Staff Presentation to the
Portland Design Commission

Design Review Hearing

LU 15-267105 DZM

604 NE 20th Ave

SOUTH ELEVATION

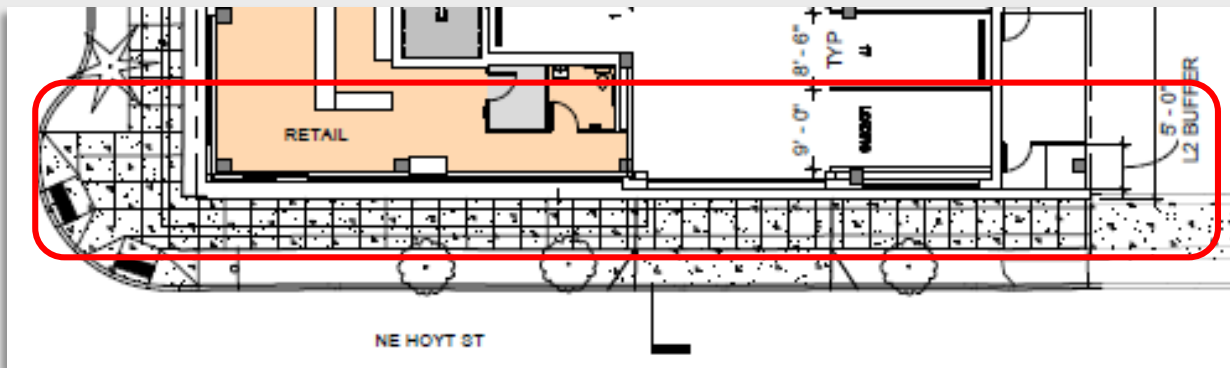
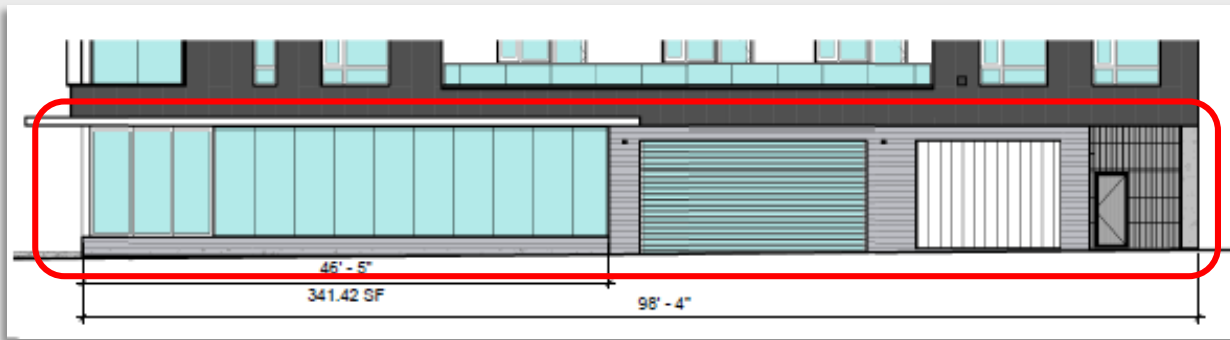
Oriel Code Guide – IBC 32/#1. F. Width – 12’ allowed, 27’ proposed.

The Oriel expression lacks contextual relevance, is out of alignment with the ground floor residential lobby and retail entry, appears volumetrically disproportionate to the corresponding NE Hoyt St recess, and does not serve to distinguish or better-organize program.

Guidelines Not Met: *P1 Plan Area Character, D7 Blending into the Neighborhood, D8 Interest, Quality and Composition.*

Façade Length	98'-4"
Standard (50%)	49'-2"
Proposed (47%)	46'-5"
Short	2'-9"
